Business Permit of JNFL Rokkasho Reprocessing Facility

November 2020
Nuclear Regulation Authority, Japan

Conformity Review for Amendment of Business Permit of JNFL Rokkasho Reprocessing Facility

External Advisors Meeting, 25 November 2020

Deto Seiho Capable Fault

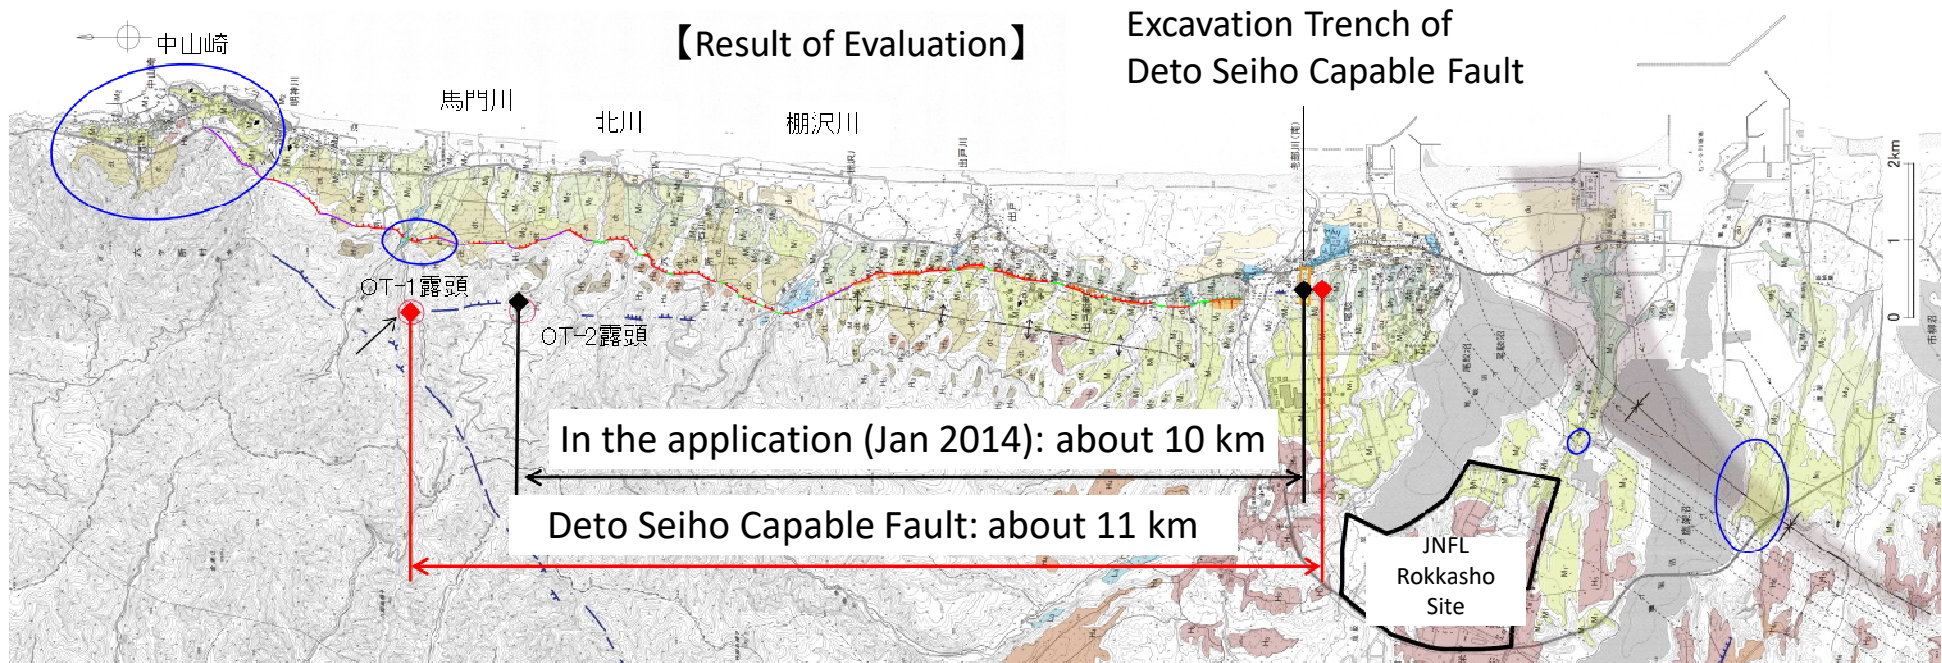
- In the initial amendment application (Jan 2014), Deto Seiho capable fault was evaluated as about 10 km long. As a result of additional survey in response to the NRA's indication, the north and south ends of the fault were reconsidered and the length was reevaluated as about 11 km. In addition, further survey was conducted in response to the NRA's comment and the licensee reconfirmed the evaluation of the length and location.

Response Spectra of DBGM

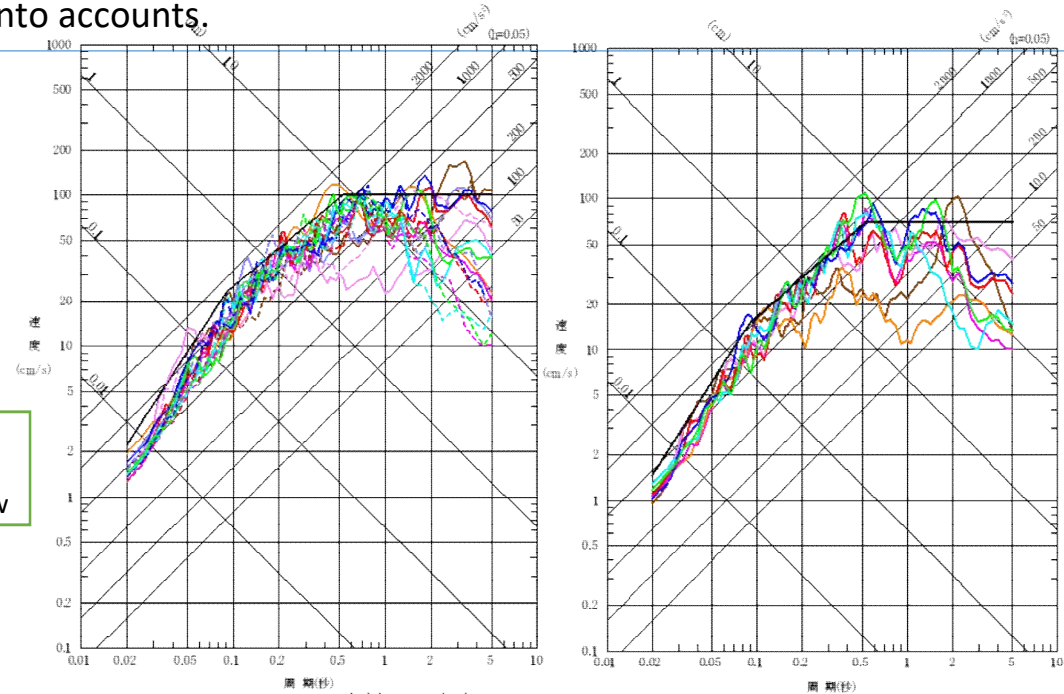
Added in the process of conformity review

The NRA confirmed that DBGMs are adequately established with various uncertainties taken into accounts enough. Thus the NRA judged that the application meets the Licensing Standards in terms of DBGM.

【Location of Volcanos in the Geographical Area】

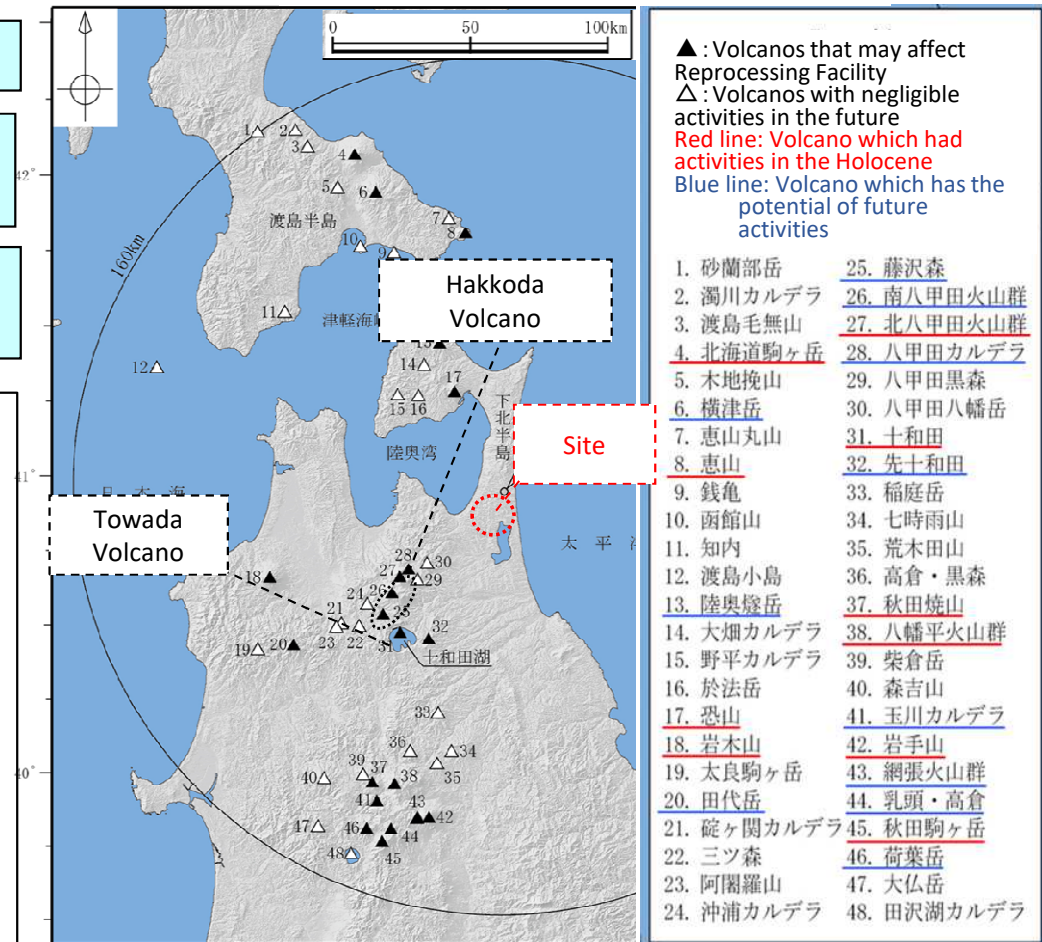
The NRA judged that the individual evaluation of volcanic activities presented by the licensee was conducted according to the evaluation guide issued by the NRA and thus appropriate.

Evaluation of extremely large volcanic eruption of both Towada Volcano and Hakkoda Volcano showed that possibilities of such eruptions during operation lifetime of reprocessing facility were small enough based on the facts that the current volcanic activities does not appear imminent and that no scientifically reasonable basis was found for possible extremely large volcanic activities during operation lifetime.

Evaluation of volcanic activities after the last extremely large activities of both Towada Volcano and Hakkoda Volcano, and of volcanic activities of the others beyond DB, showed that possibilities of such eruptions causing damages to DB facilities were small enough based on the facts that physical distances between volcanic origins and facilities are sufficiently away from each other.

However, in view of the evidences of ancient pyroclastic flows that were found in the Rokkasho site, the licensee should annually conduct seismic, geophysical and geodetic monitoring of Towada Volcano and Hakkoda Volcano to confirm stability of the volcanic activities since the time of licensing.

Figure: an Example of EDG Air Intake

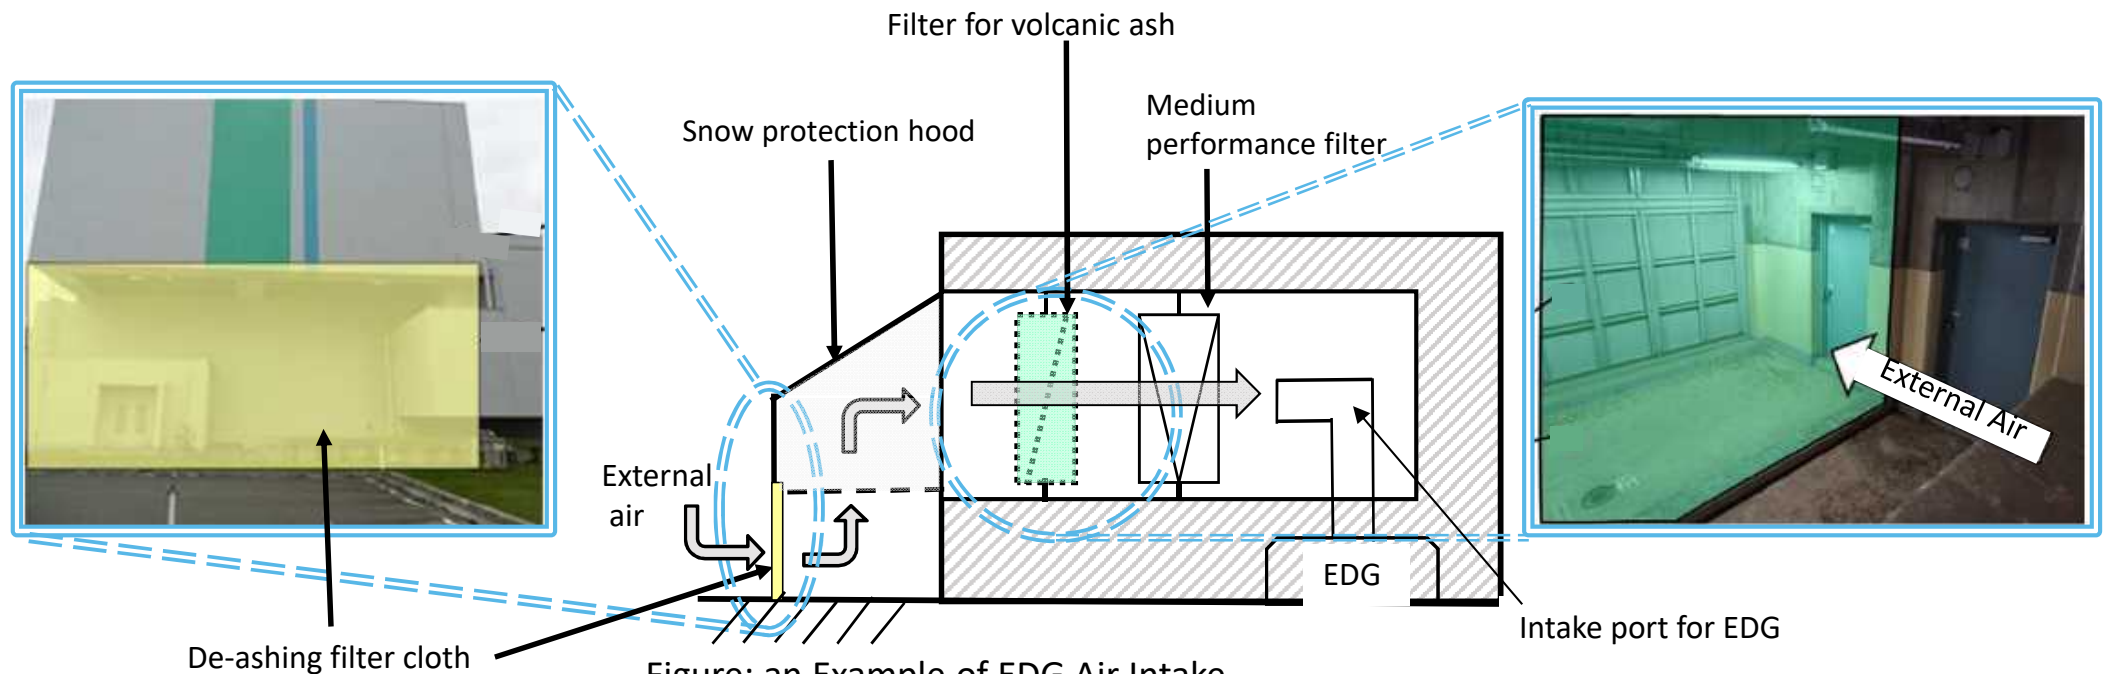
- Design buildings and outdoor equipment to endure 0.55m of accumulated volcanic ash.
- Install filters to prevent volcanic ash from entering the facility, e.g. at an intake port of emergency diesel generator.
- Paint exteriors of buildings so that the safety function is not impaired by corrosion caused by volcanic ash.

The NRA judged that the safety function of DB Facility is not impaired against volcanic activity, thus conforms to regulatory requirement.

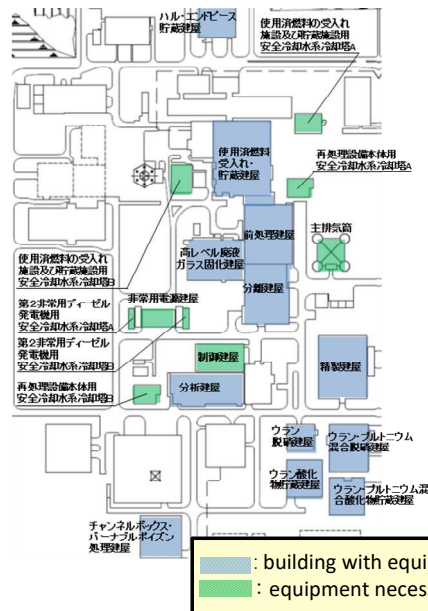
- Evaluate effects based on the NRA's direction how to apply reactor's external fire guide to reprocessing facility;
 - Assuming fire breaks out on exterior wall of the buildings since the buildings locate close to each other, not applying the concept for reactor in which crash point is postulated.
- By implementing protective measures as necessary, safety function of facilities are not impaired due to fire caused by airplane crash.

The NRA judged that the evaluation of exterior wall temperature are conducted properly according to the NRA's direction, and the design is made for the safety function of buildings and necessary equipment not to be impaired by the fire.

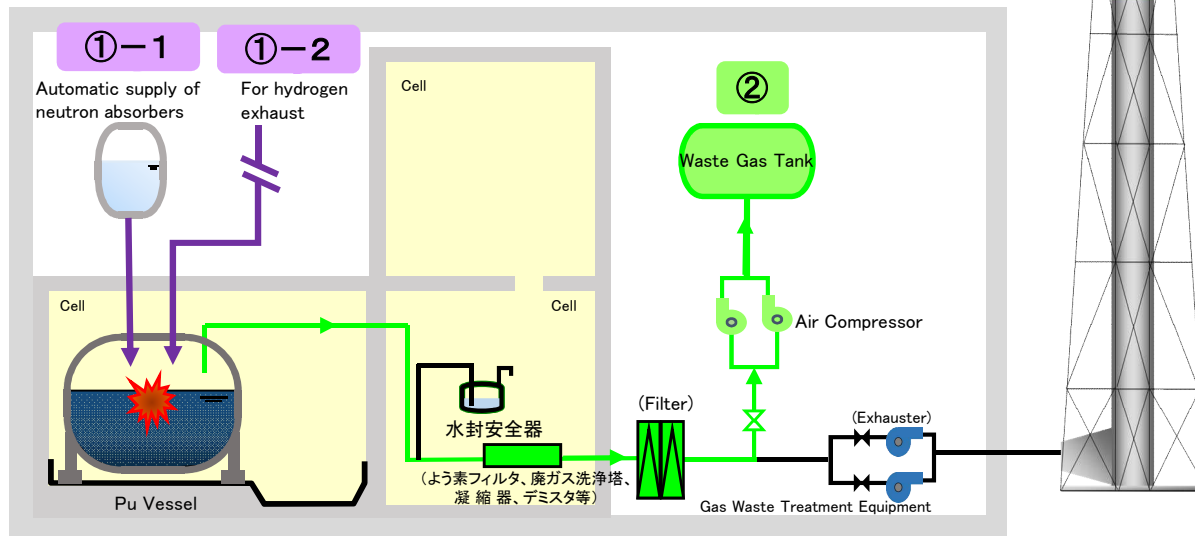
- Effectiveness evaluations were conducted assuming criticality accidents occur in 8 storage vessels.
- Each measure captures the characteristics of criticality accident progression such as supply of soluble neutron absorbers, additional hydrogen exhaust capability for hydrogen explosion prevention, and guiding radioactive gaseous toward waste gas tank to suppress the release of radioactive materials.
- Amount of radioactive materials released to outside of the site is evaluated lower than 100TBq and as low as practicable.
- Equipment and procedures necessary to take measures against criticality accident are set up.

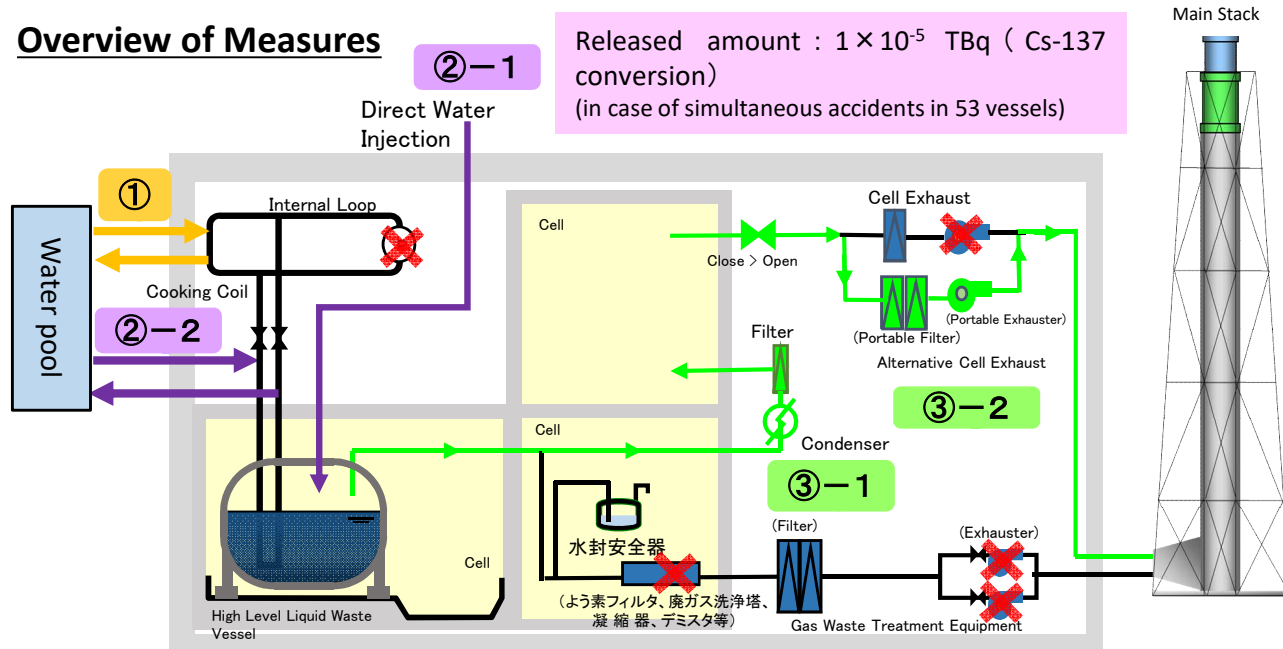
- Effectiveness evaluations assuming the accident occur in 53 vessels simultaneously were conducted.
- Each measure captures the characteristics of accident progression.
- These measures enable to maintain the liquid level constant and maintain temperature of high level liquid waste including Ru under 120 °C, subsequently, to converge situation by cooling vessels.
- Amount of radioactive materials released to outside of the site is evaluated lower than 100TBq and as low as practicable.
- Equipment and procedures necessary to take measures against criticality accident are set up.
